**RE: LHM Jeep
Grading and Drainage Plan (Stamp Date 3-31-2016)
Hydrology File: K19D023**

RE: LHM Jeep Parking- K19D023
Comments March 04, 2016

Comments on 1-27-16 submittal:

From: Abiel X. Carrillo
To: ["arverdt@awaeng.com"](mailto:arverdt@awaeng.com)
Cc: [Cherne, Curtis](#); [Harmon Rita T.](#)
Subject: RE: LHM Jeep - K19D023 - Stamp Date 3-31-2016
Date: Monday, April 11, 2016 5:11:00 PM

Demolition Plan

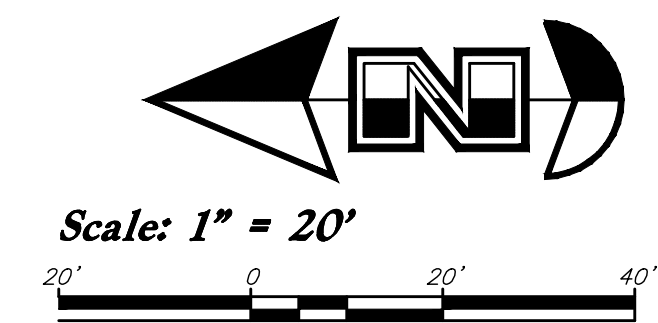
Comment: Add a general note to replace curb and sidewalk stones to nearest joint.

Response: Note added, Sheet C0.1, Demolition Plan, General Demolition Note 18: Replace curb and sidewalk stones to the nearest joint.

18. Replace curb and sidewalk stones to the nearest joint.

Albuquerque Standard Drawing 2405B

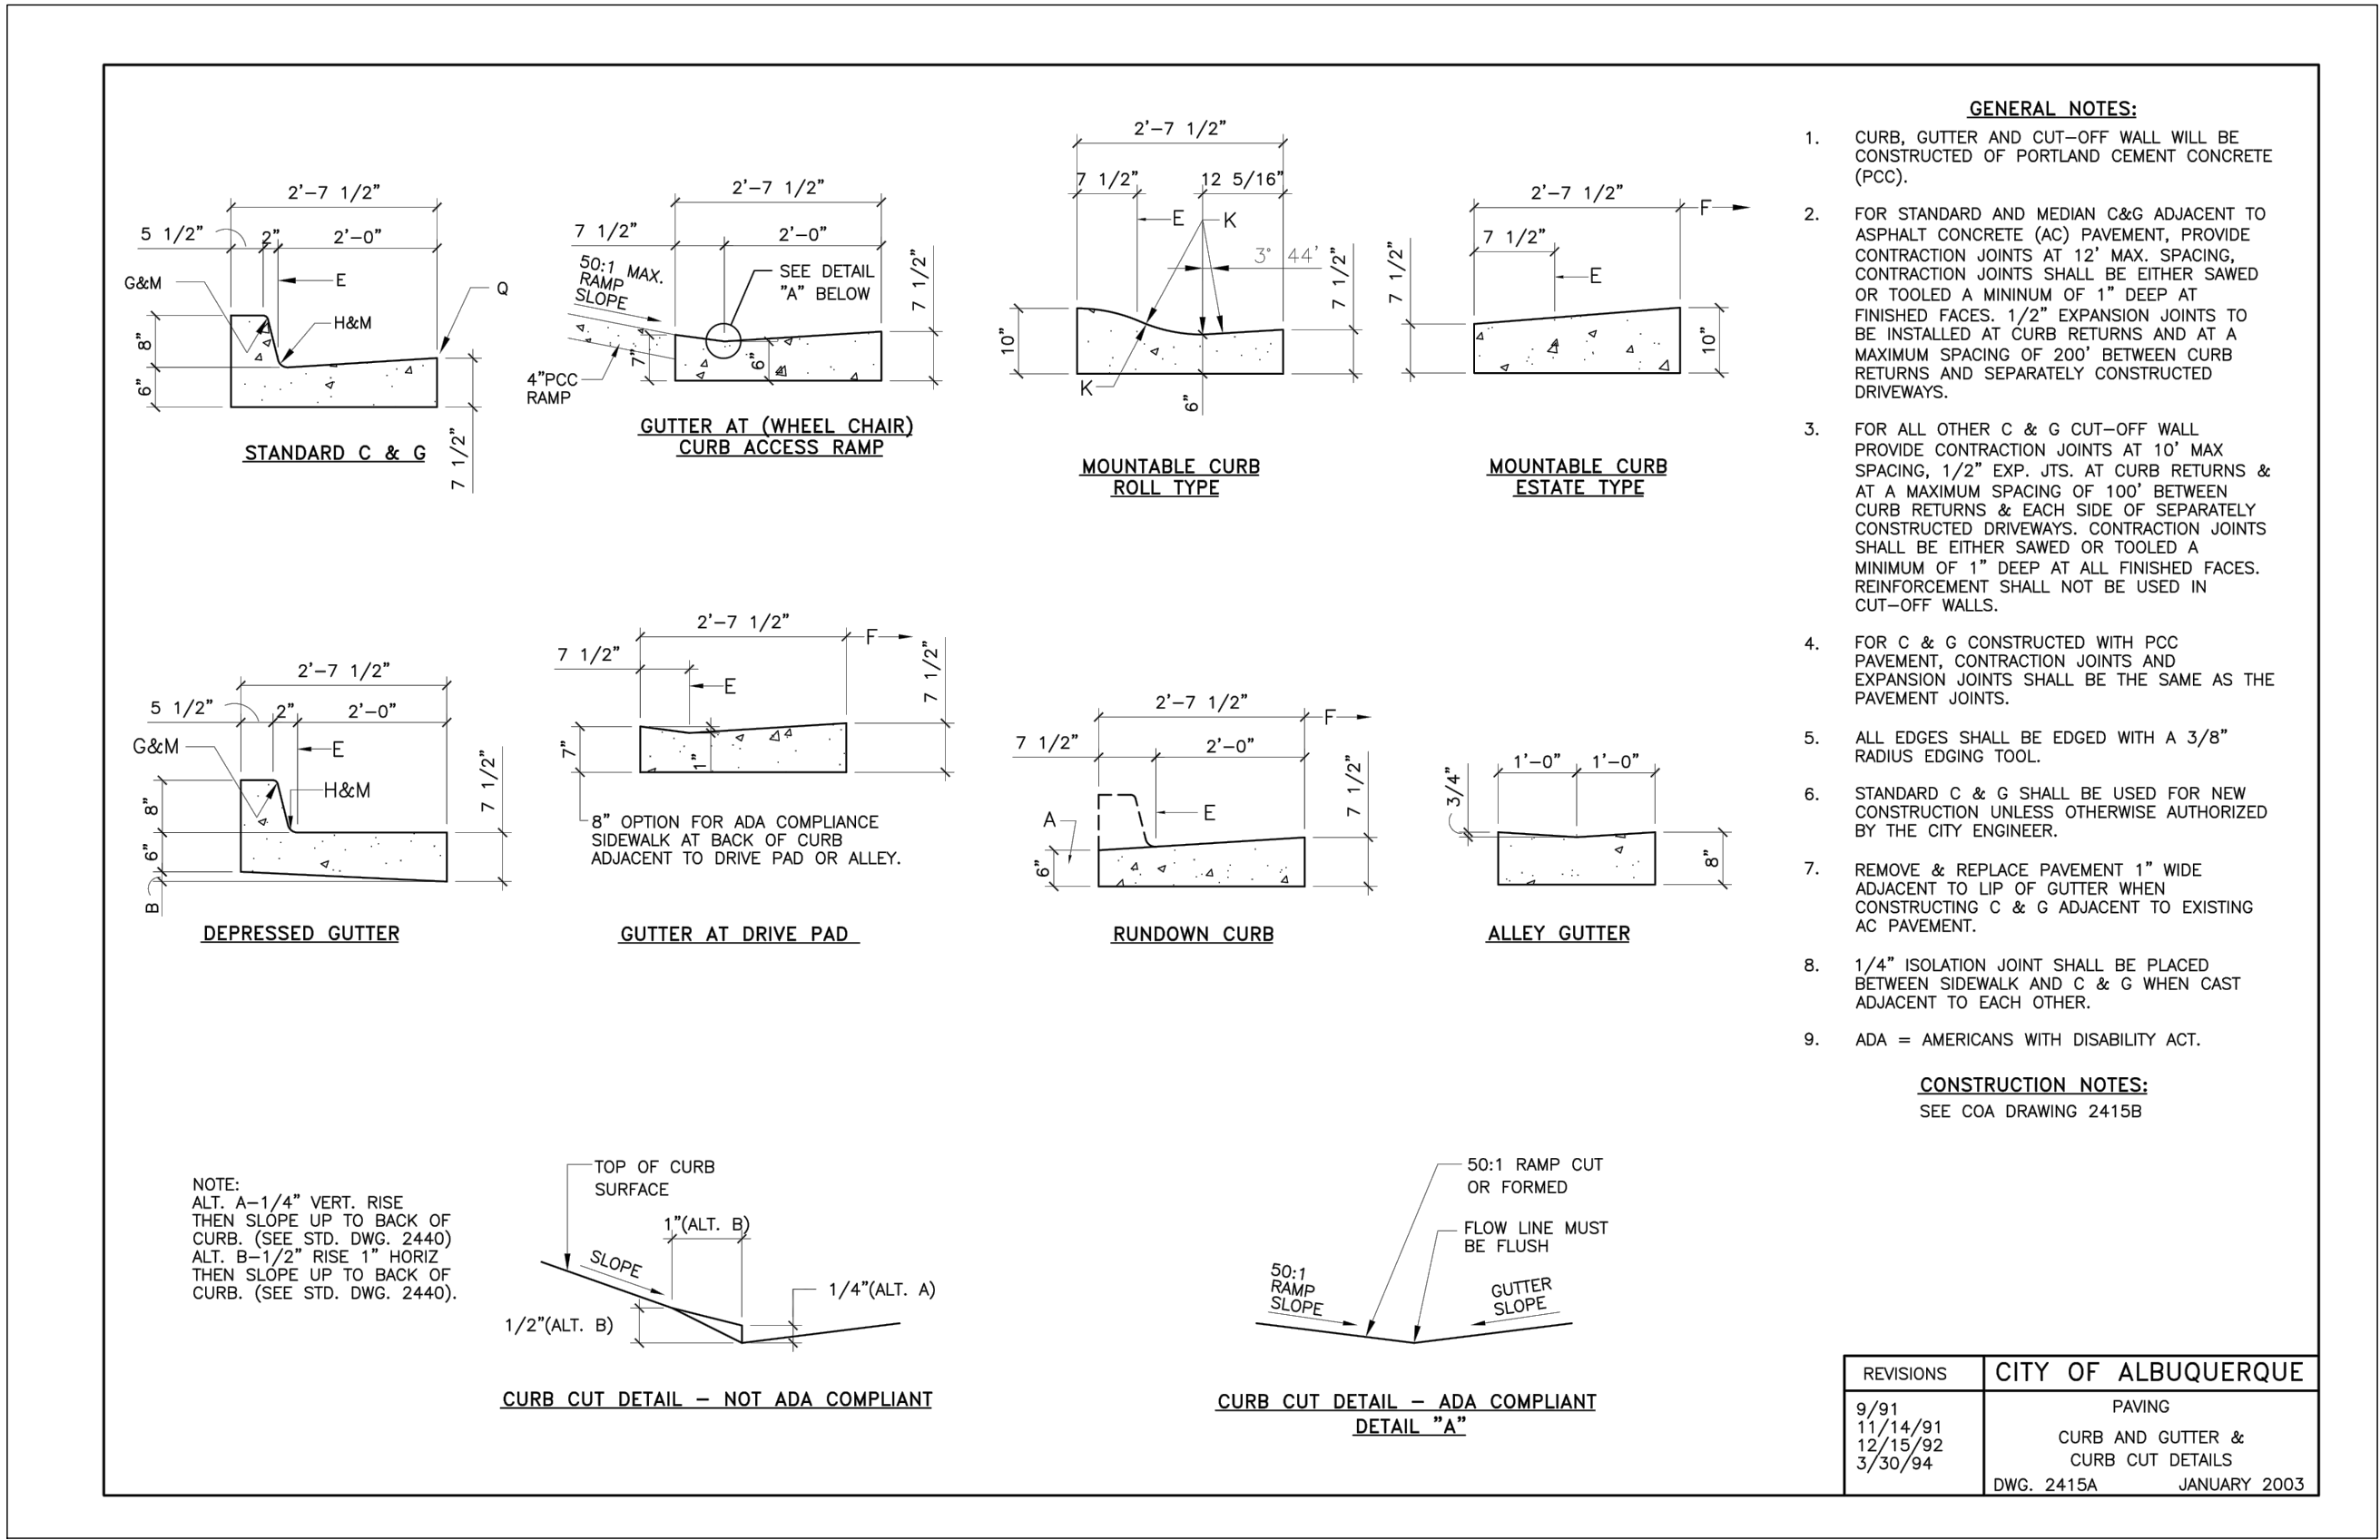
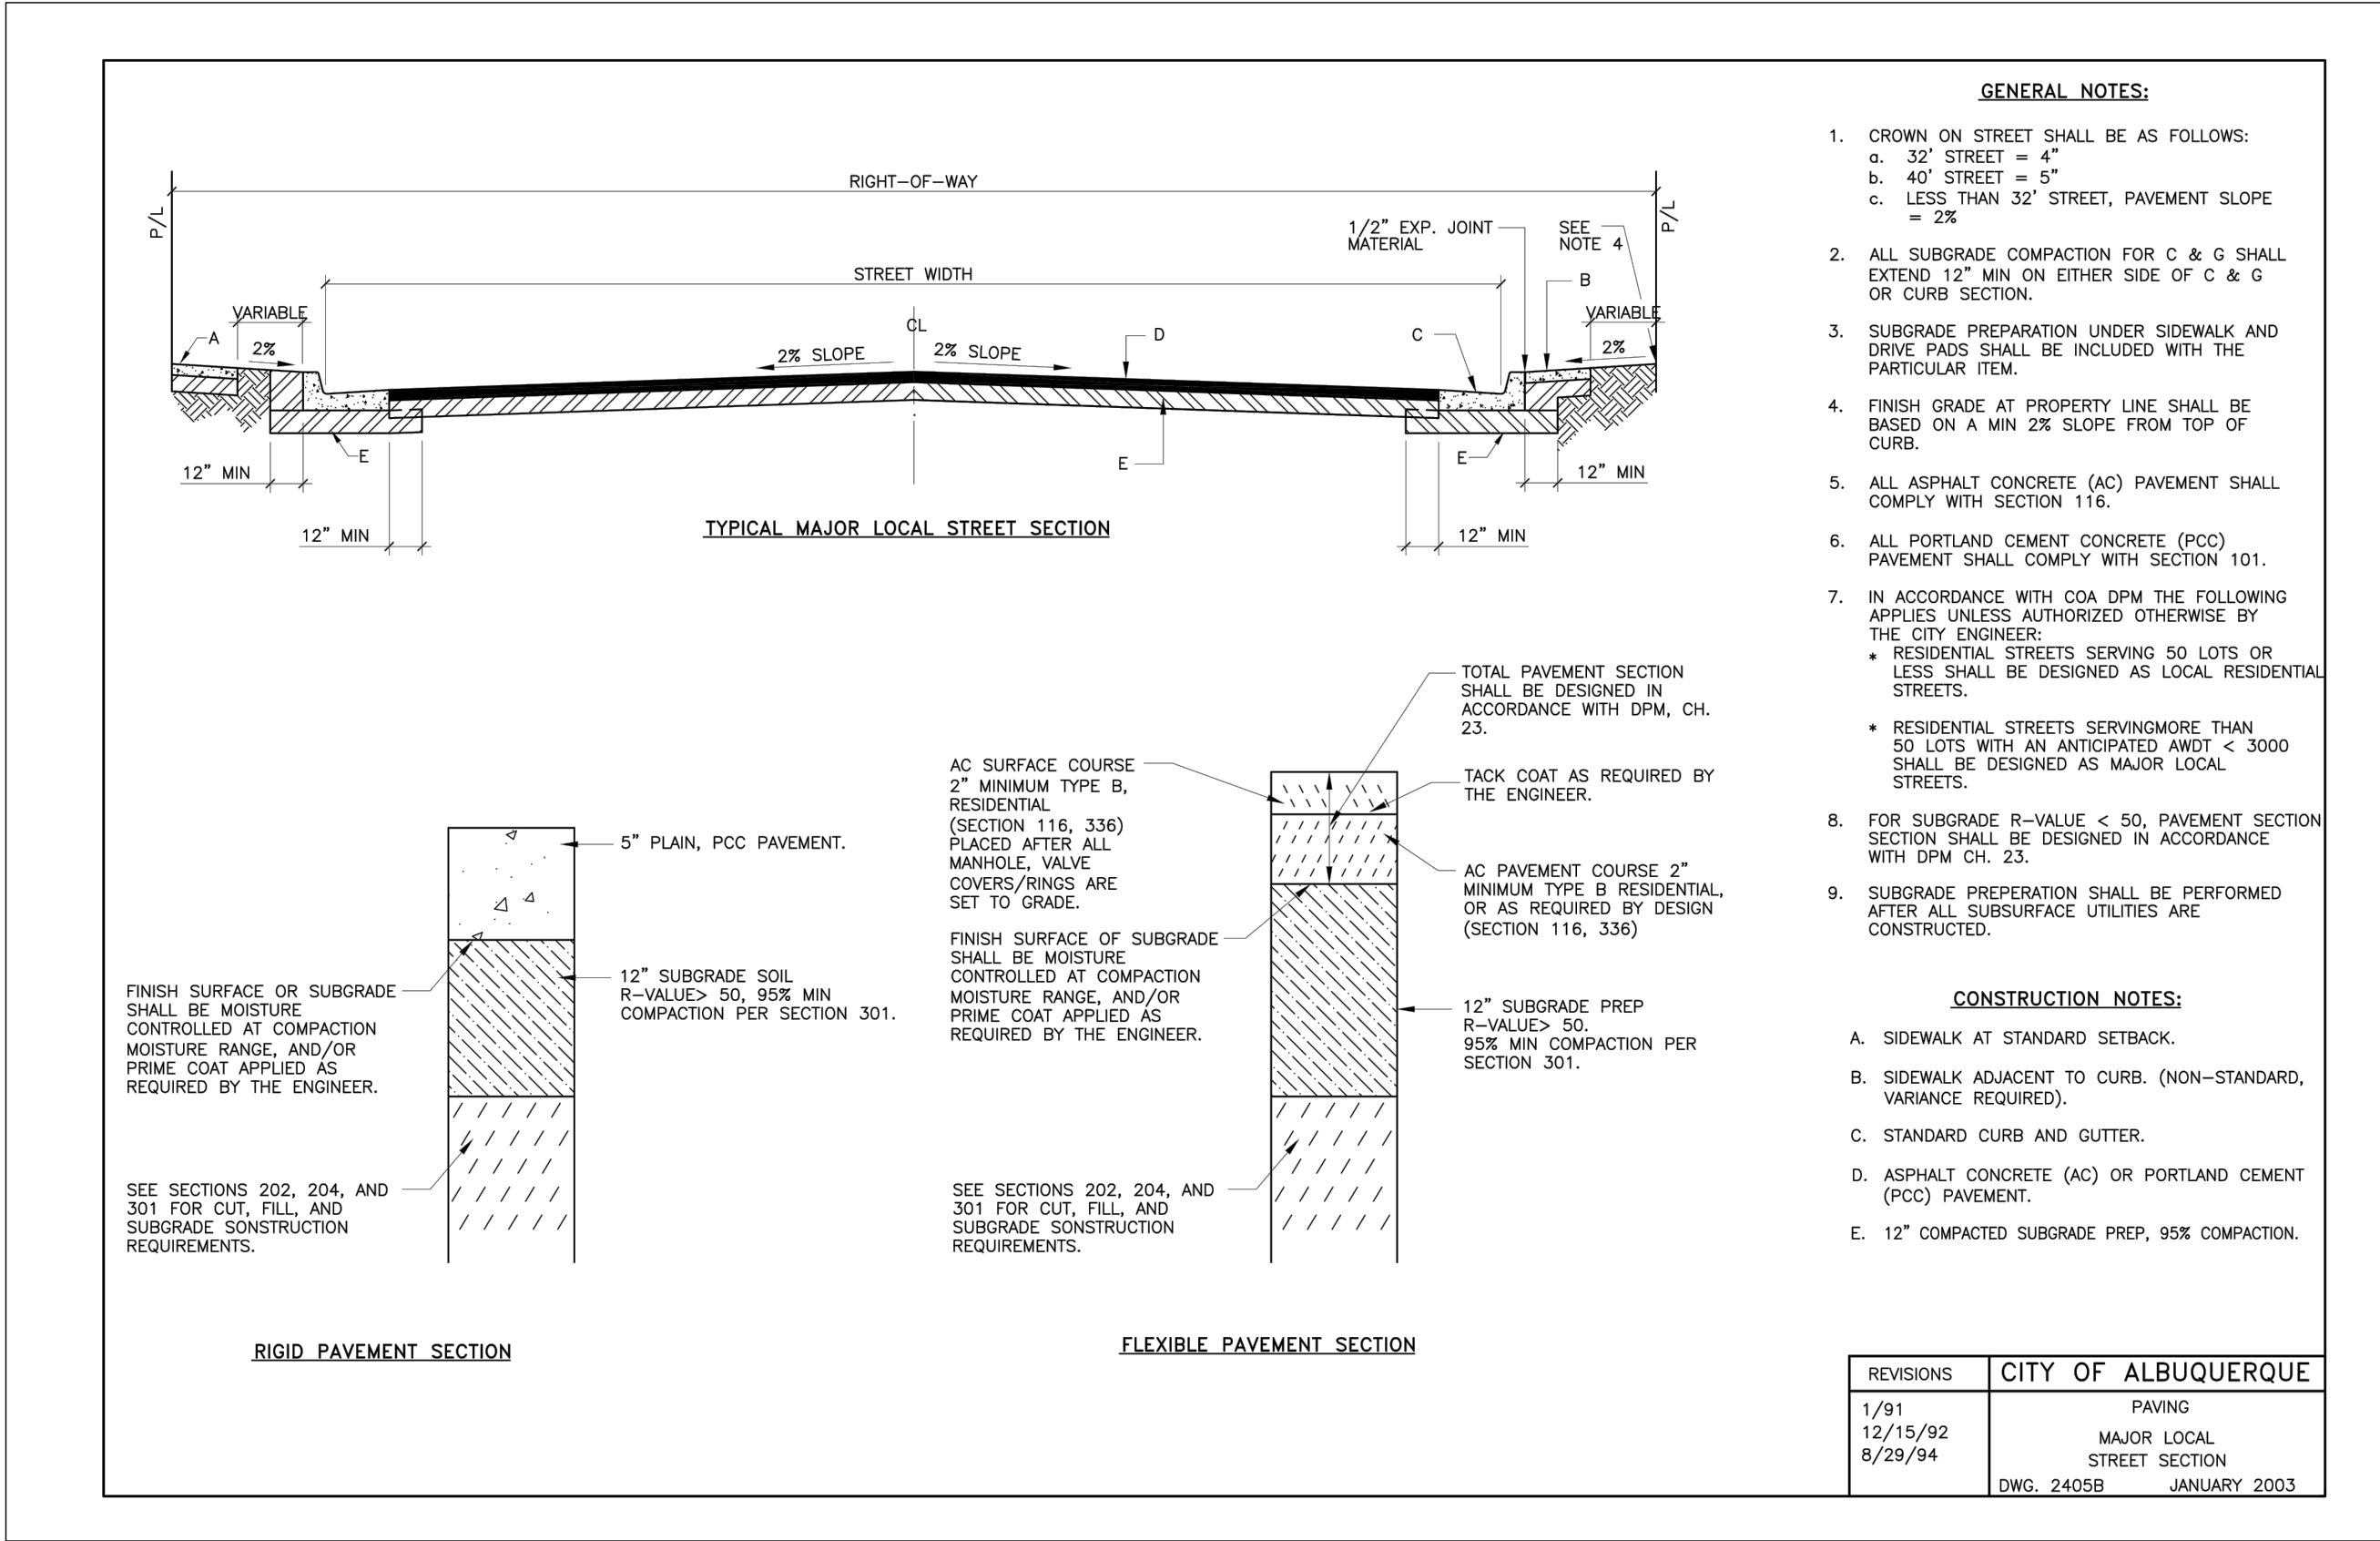
Comment: The City has implemented a new standard drawing for street sections (2405A and B) that shows a depression between the back of curb and the back of sidewalk (for detached sidewalks). In this case, please show a depression between the back of sidewalk and the property line (4"-6" where practicable), to mitigate the storm runoff from the right of way into the property.

Response: Okay, depression added, and detail added to plans.
